### **ChiCycle Objection to Planning Application 22/01485/OUTEIA Phase-2 of the West of Chichester Development (Part 2)**

ChiCycle object on grounds that the proposed parallel crossings fail to follow appropriate guidance from the DfT Traffic Signs Manual.

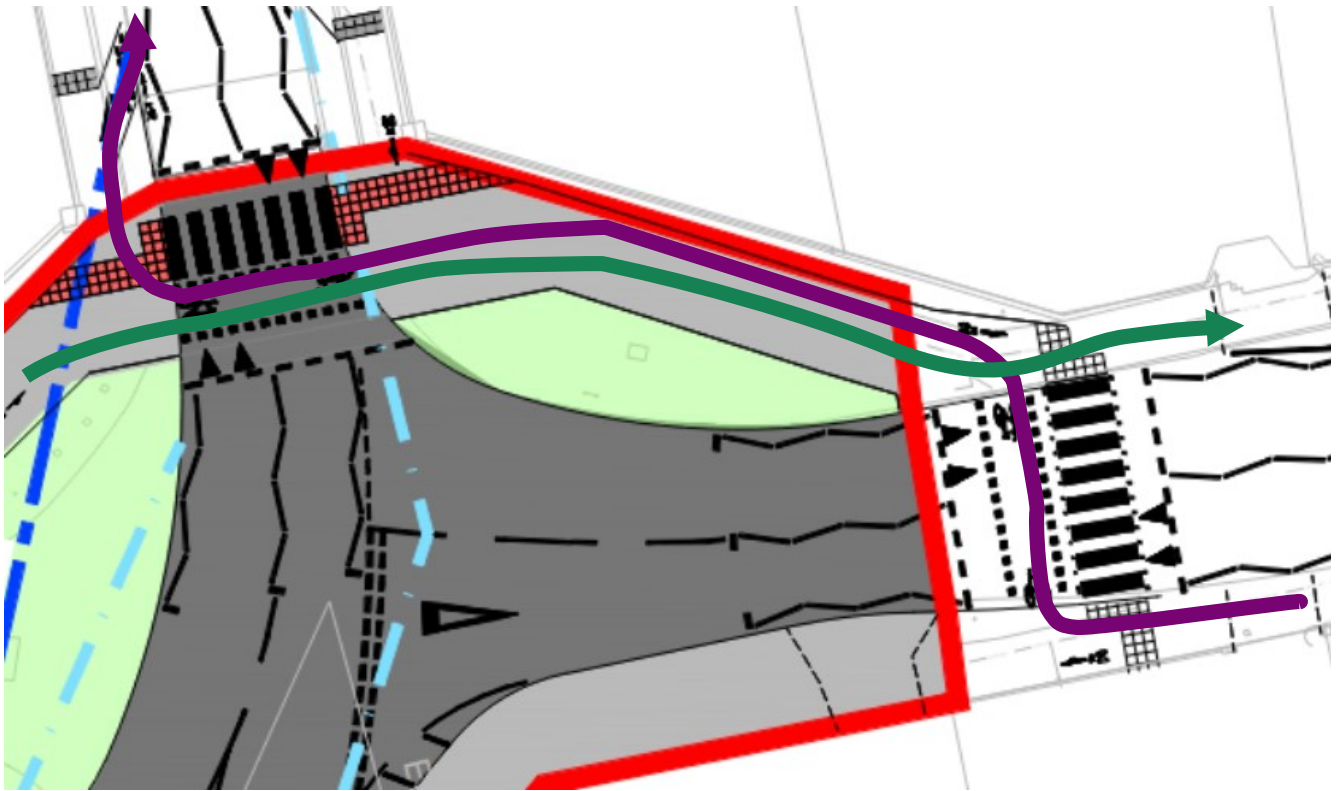
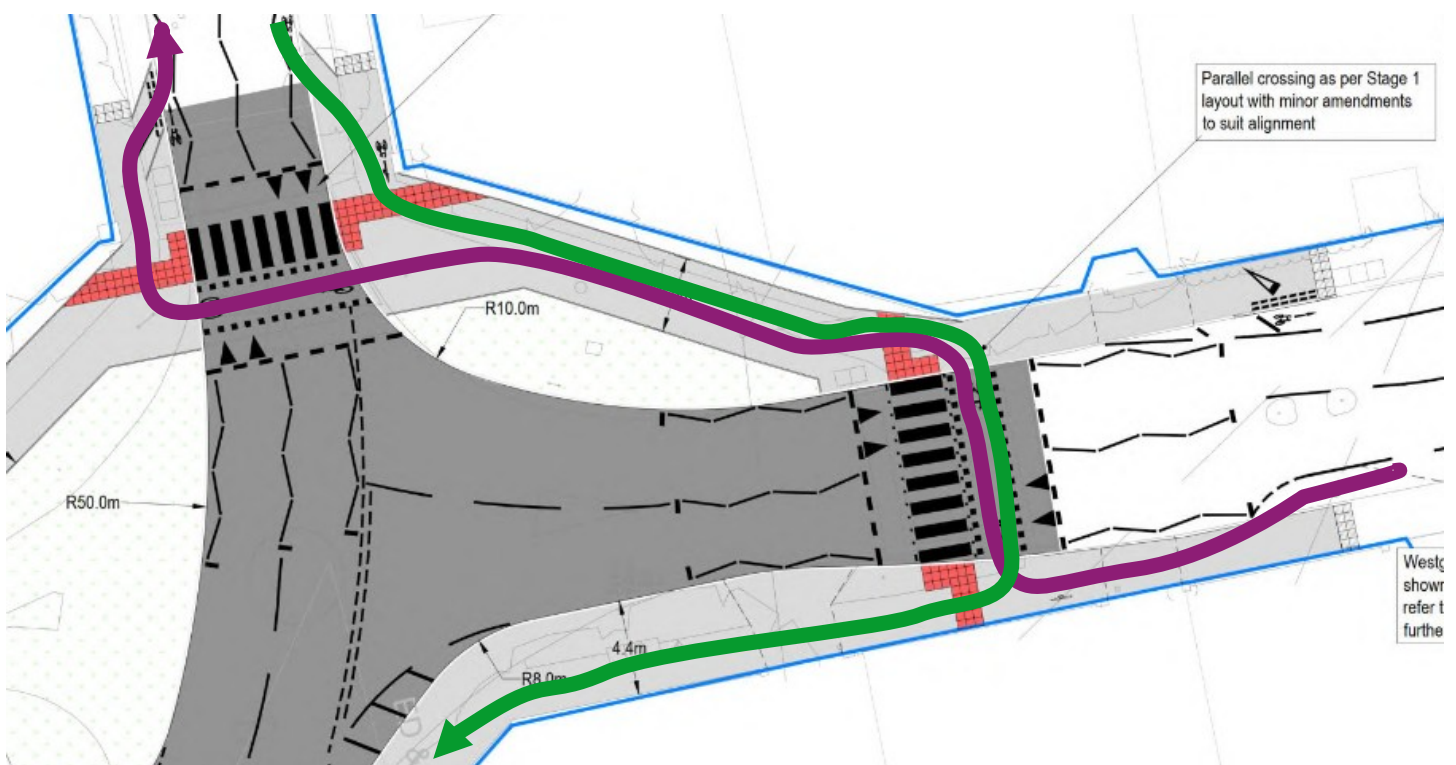
The diagram below shows part of the proposed junction between Westgate and Sherborne Rd. It is reasonable to expect cyclists to use the proposed parallel crossing on Sherborne Rd in either direction. The purple and green lines show valid routes.

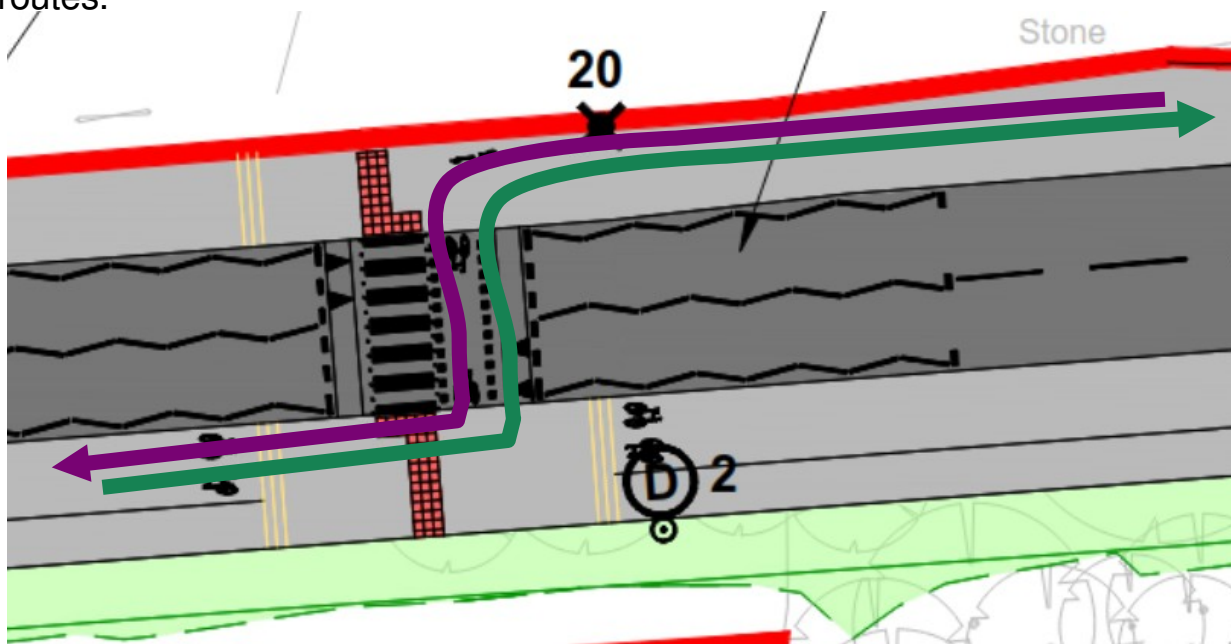
It is equally reasonable to expect cyclists to use the proposed parallel crossing on Westgate to travel in either direction. The purple and green lines show valid routes in this 2<sup>nd</sup> example.

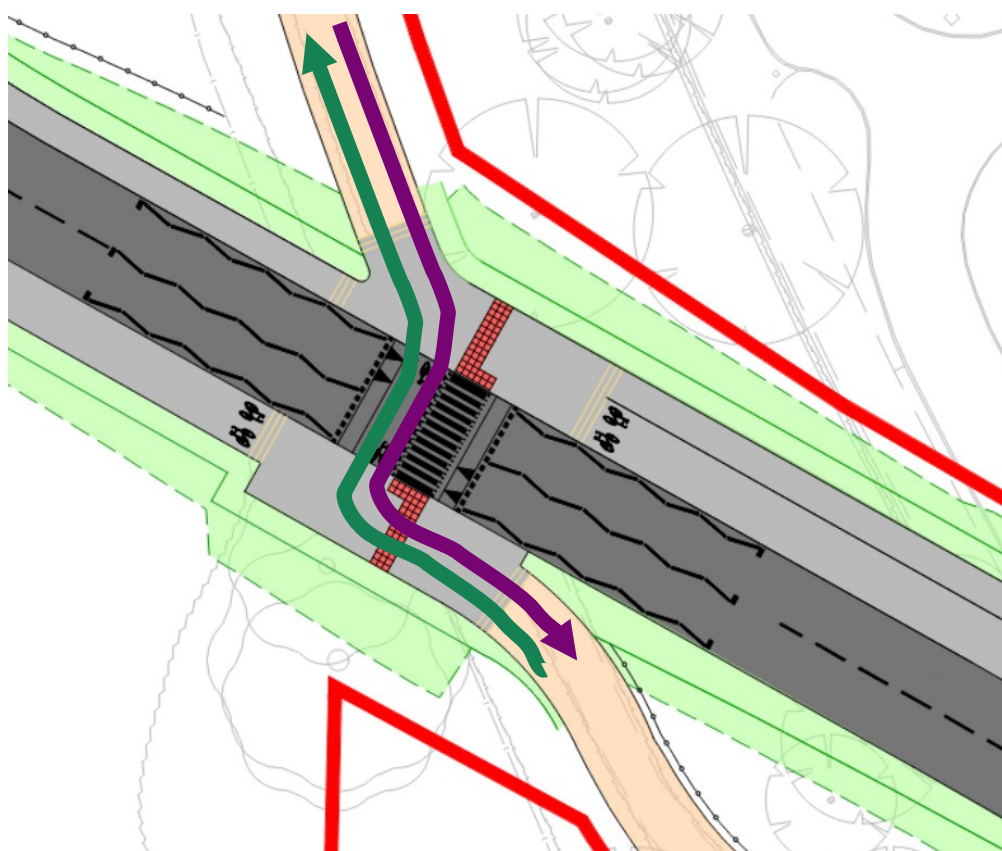
The proposed crossing to the immediate West of the junction between Westgate and Sherborne Rd is shown below. Again, it is reasonable to expect cyclists to use the proposed parallel crossing to travel in either direction. The purple and green lines show valid routes.

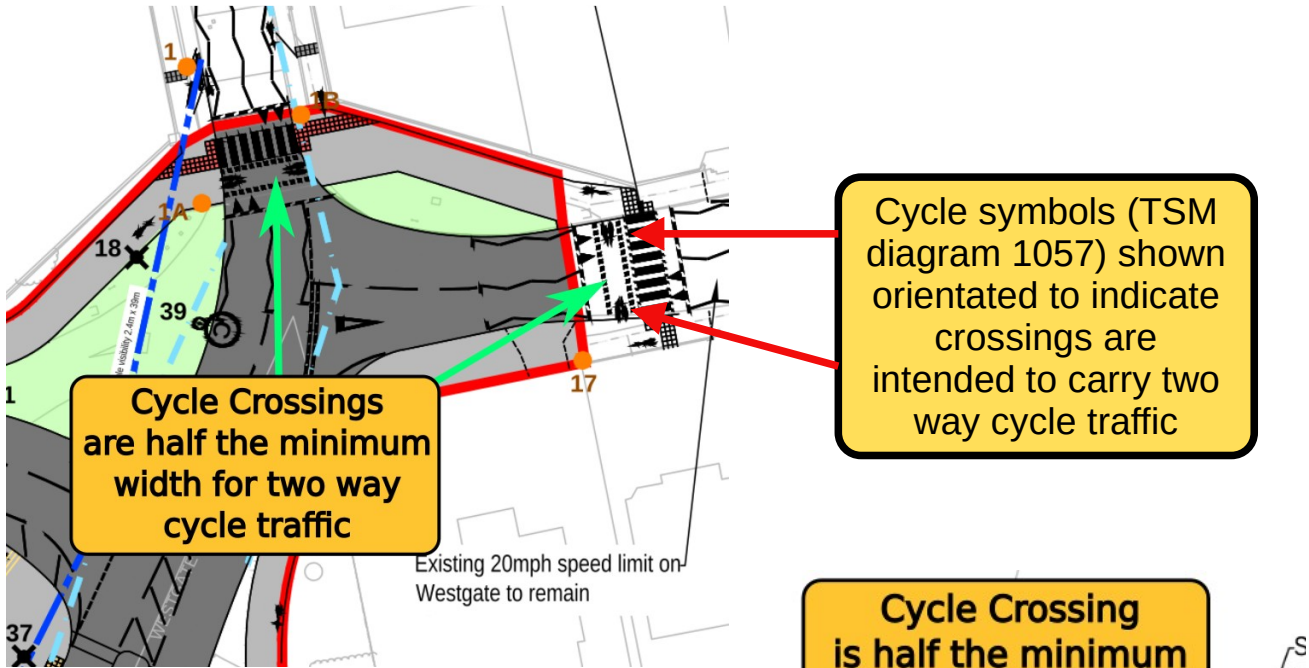
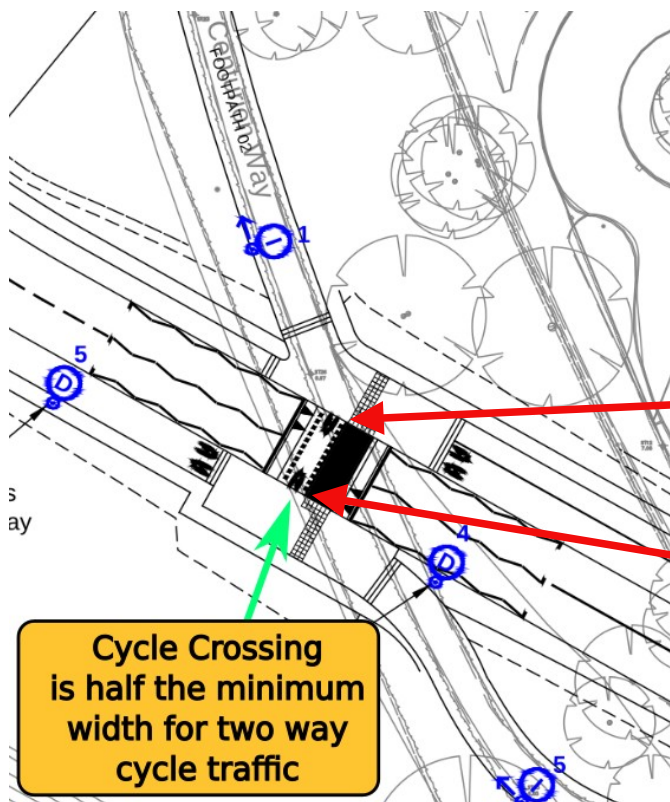
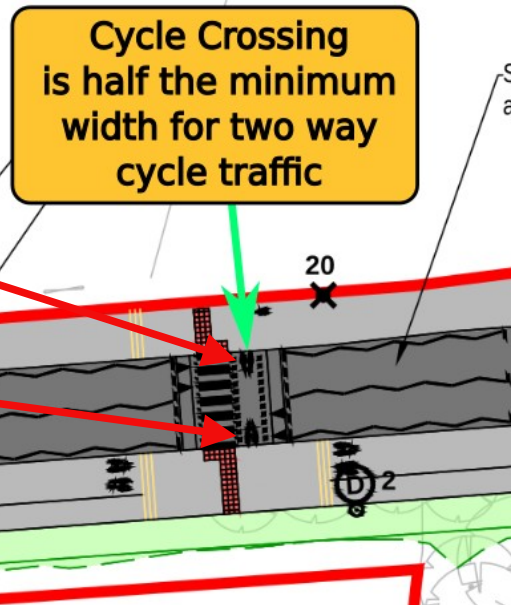
The proposed Southern Access Road crosses Centurion way as shown in the diagram below. It is reasonable to expect cyclists to use this crossing in both directions.

If implemented, all the proposed crossings will be used by cyclists travelling in either direction (two way traffic). However, the proposals clearly do not meet the recommended minimum 3 metre width for two way cycle crossings.

The following diagrams illustrate the cycle crossings are approximately half the minimum width for DfT compliance for two way cycle traffic

Cycle symbols (TSM diagram 1057) shown orientated to indicate crossings are intended to carry two way cycle traffic

Cycle symbols (TSM diagram 1057) shown orientated to indicate crossings are intended to carry two way cycle traffic

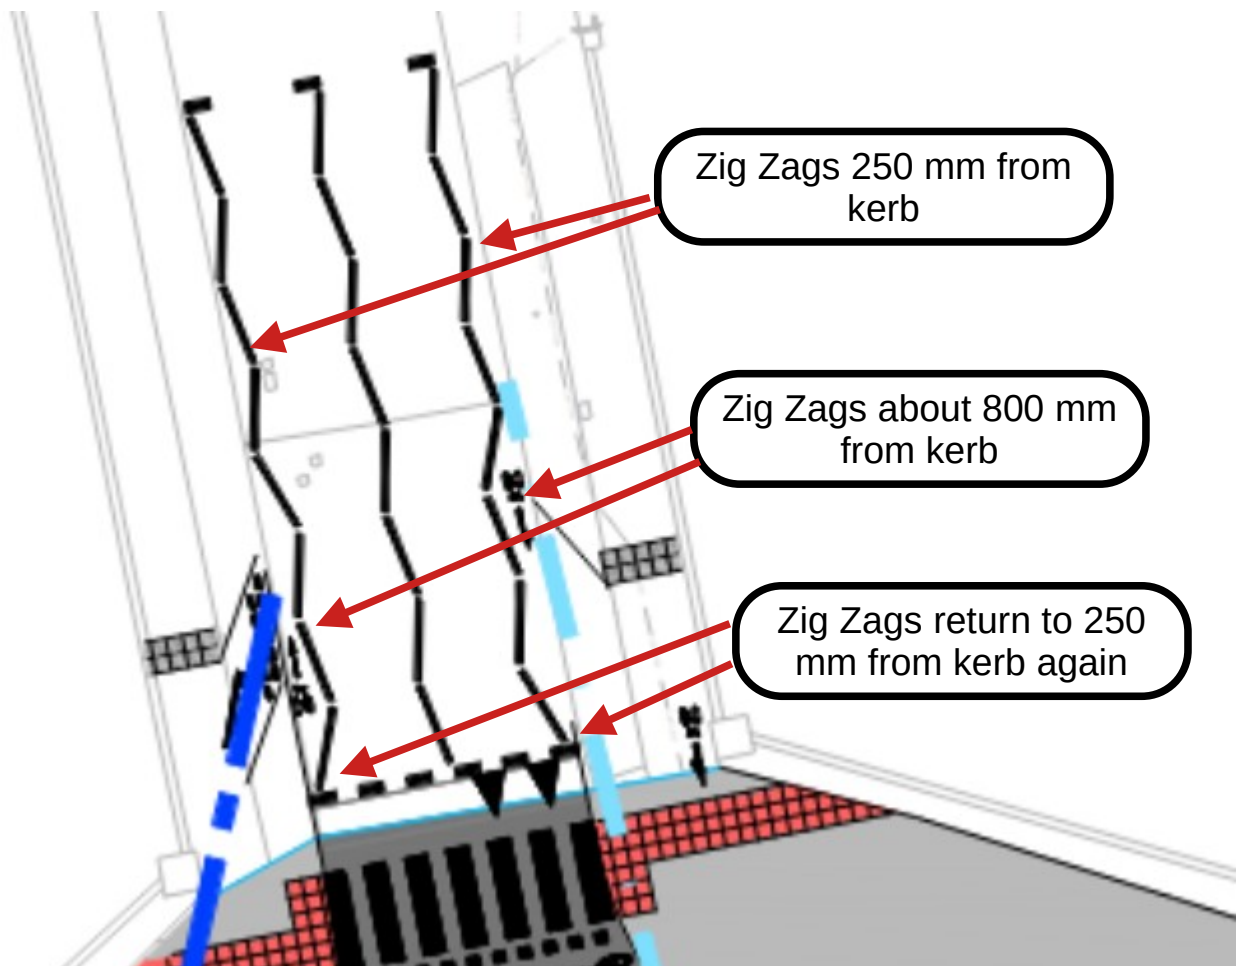
This proposed element of highway design is of such poor quality, ChiCycle doubt there has been adequate guidance and supervision in the drawing office. ChiCycle previously [objected](#) to this element of poor quality design when it was first included in [\(TRO\) CHS9038RC](#). Our previous objection has received no response.

Nothing within the DfT Traffic Signs Manual suggests the zig zag line markings can meander away from the carriageway edge to allow inclusion of confusing (and forbidden) road markings close to the kerb. Normally, zig zag lines follow a precise geometric formula for placement leaving them 250mm from the edge of the carriageway. A recent addition to DfT guidance allows zig zag lines to be inset at a constant distance between 1.5 metres (minimum cycle lane width from LTN1/20) and 2 metres (maximum according to Traffic Signs Manual volume 6 paragraph 15.8.1). In this case they signify that a cycle lane runs behind them and runs across the zebra or parallel crossing. No other geometry is permitted by the DfT.

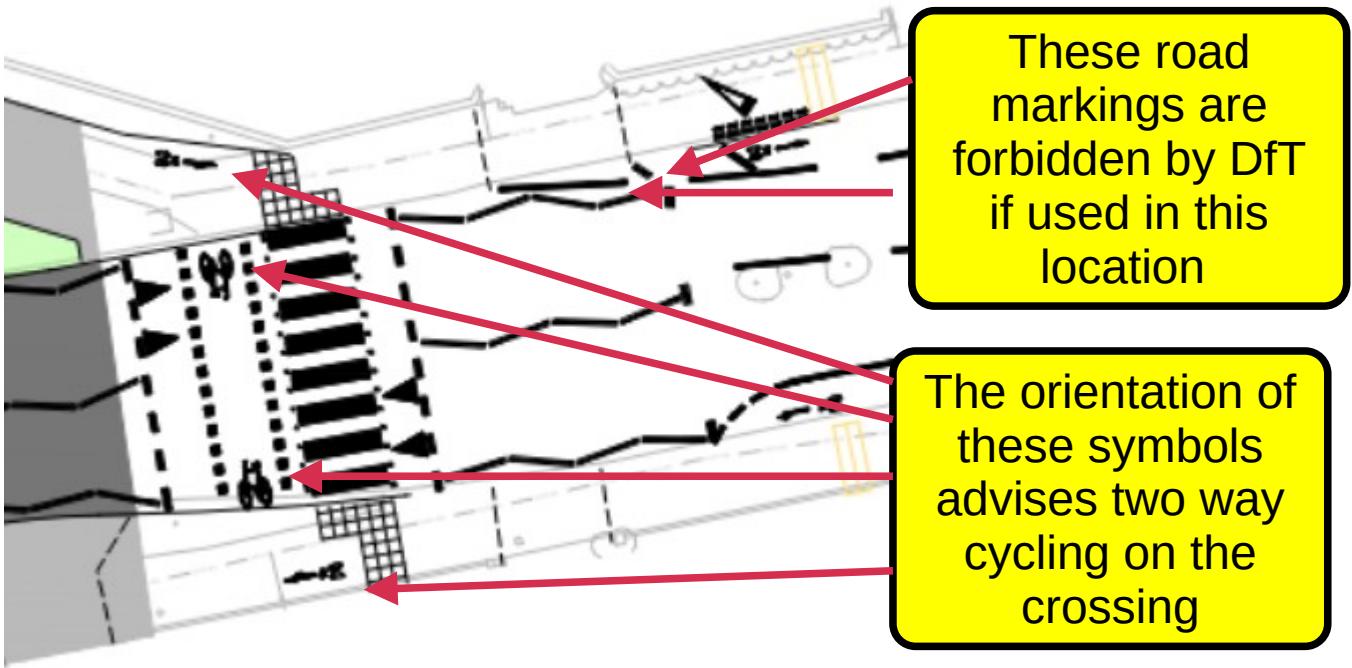
The following diagram of the proposed parallel crossing at the immediate east of the Westgate/Sherborne-Rd junction show use of forbidden hatching and line markings within a crossing controlled area.
